Technical Service Information

BMW ZF-5HP-18 NO MOVE OR DELAYED ENGAGEMENT

Figure 1

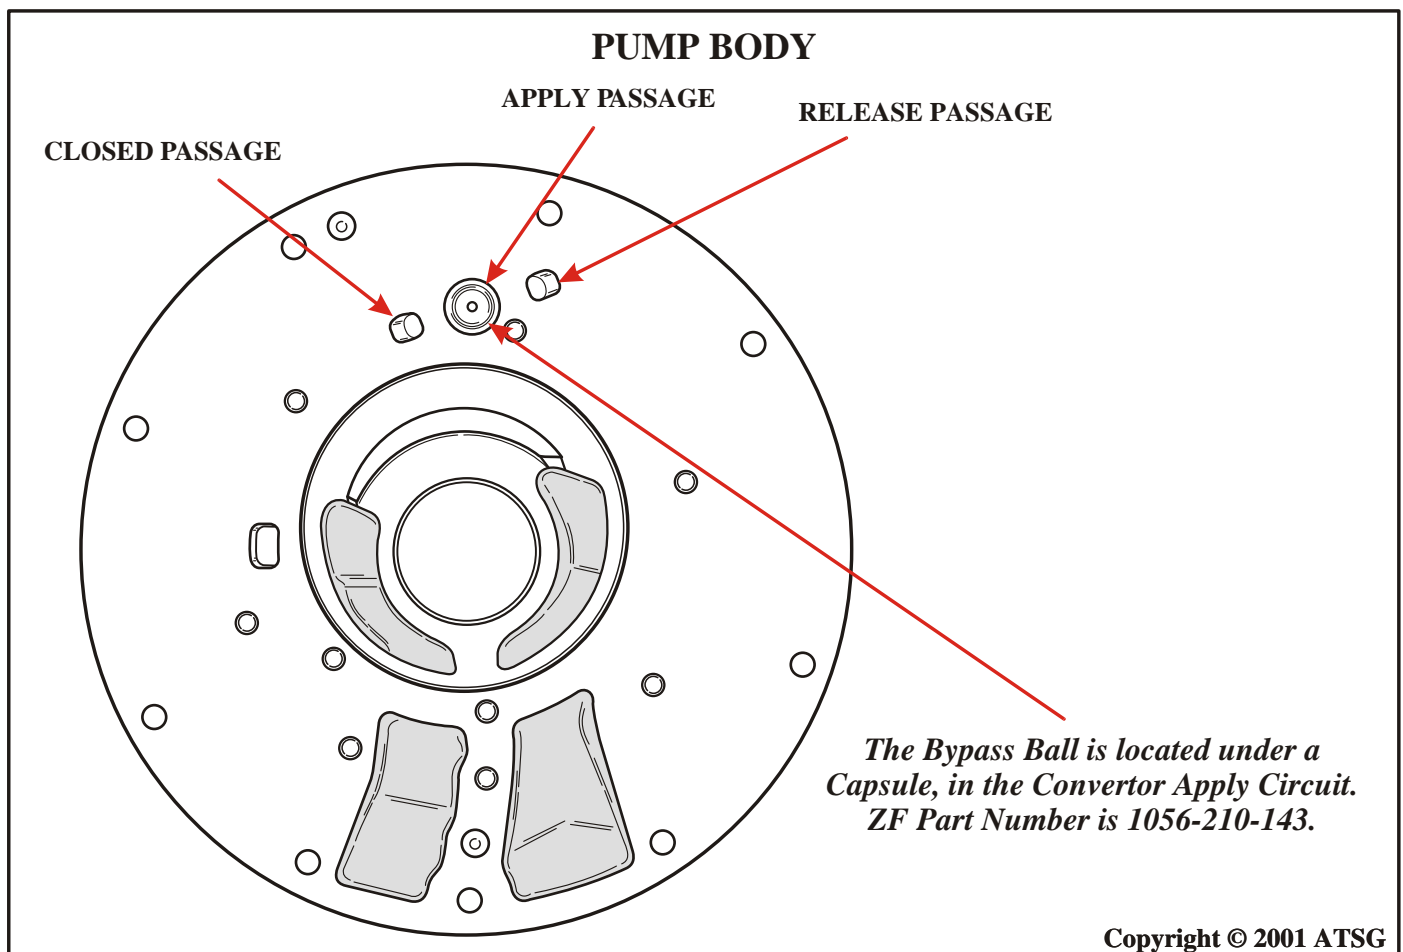
CAUSE: The cause may be, that the "Bypass Ball," located in the pump as shown in Figure 1, may have shrunken down and traveled back through the pump passage leading to the Torque Converter Valve, sticking the valve in the "stroked" position (See Figure 2). When this valve is stuck in this position it may cause the Torque Converter to drain-back after sitting for a prolonged period of time. When the vehicle is started after sitting, it may take 10 to 15 minutes for the Torque Converter to fill back up, and this all depends on the positioning of the stuck Torque Converter Valve.

CORRECTION: Locate the Torque Converter Valve, as shown in Figure 3 , and free the valve up, removing the shrunken Bypass Ball from binding the valves movement. Replace the assembly in pump body with a new one from ZF, available under ZF part number 1056-210-143, if the capsule can be removed from the pump body (See Figure 1).

ZF-5HP-18 LOCKUP HYDRAULIC CIRCUIT

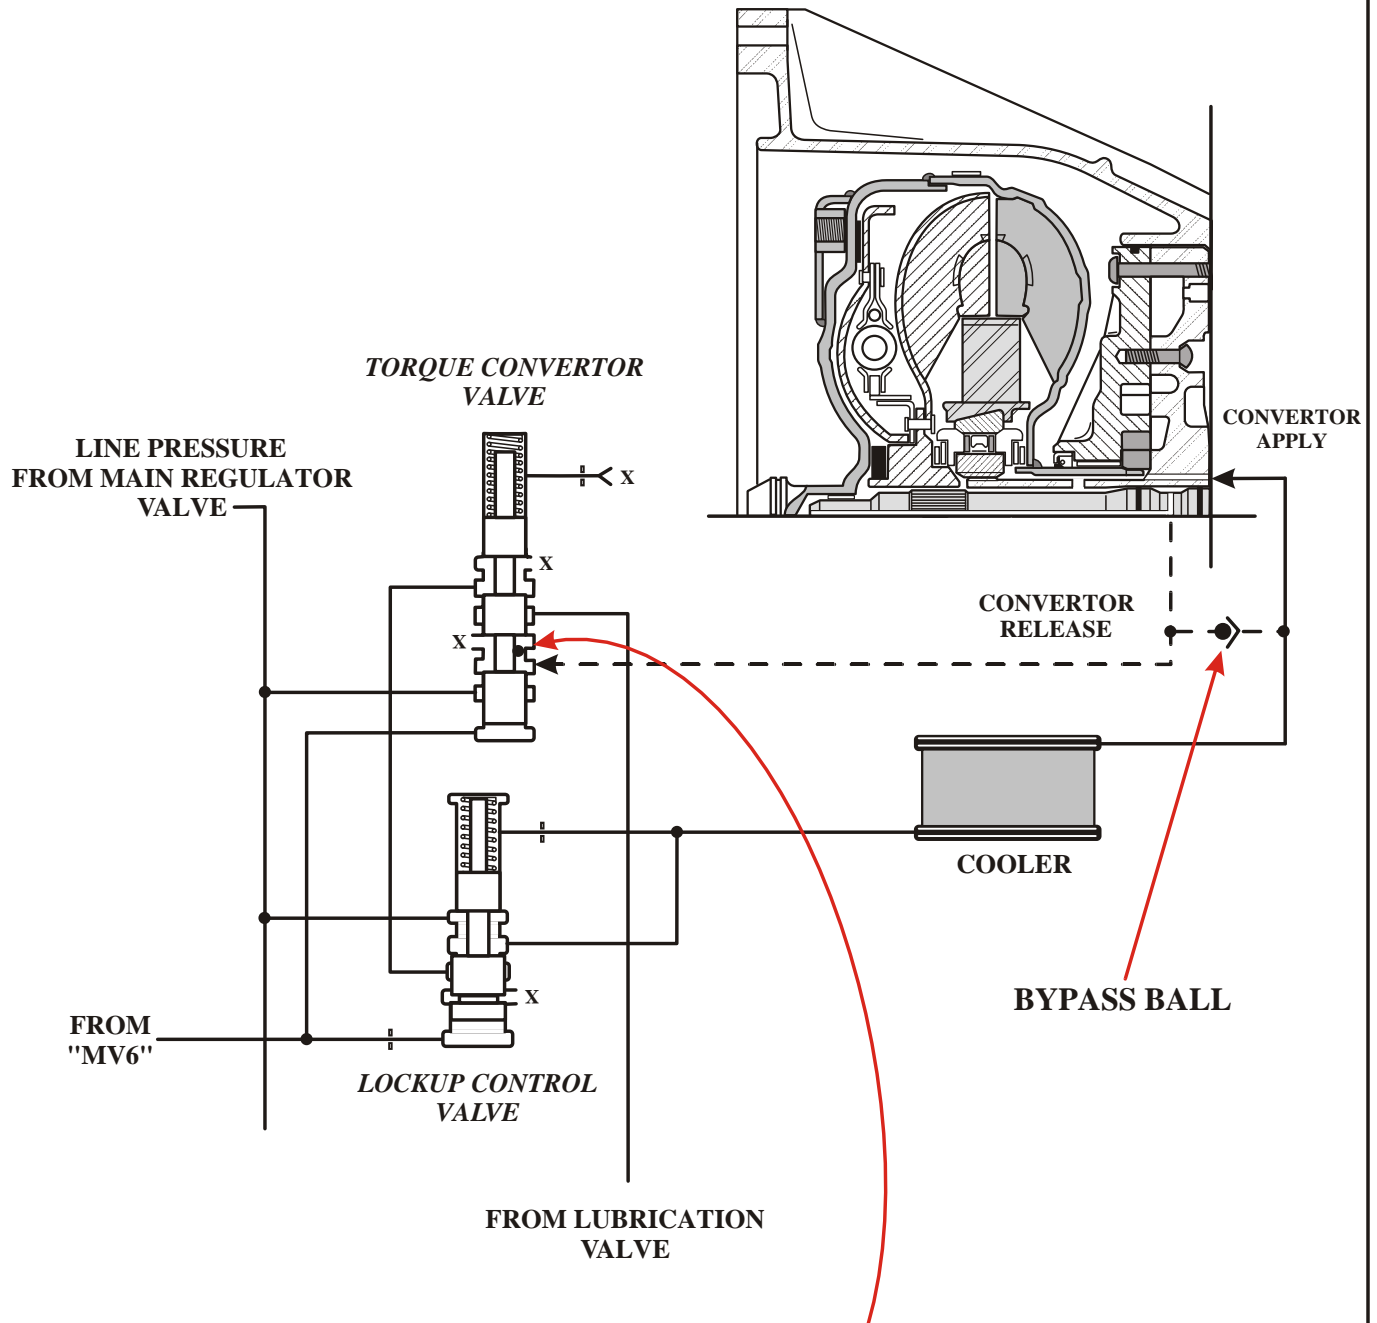
The "Bypass Ball" shrinks and travels back through to the Torque Converter Valve and lodges itself in this passage, sticking the valve in this approximate position.
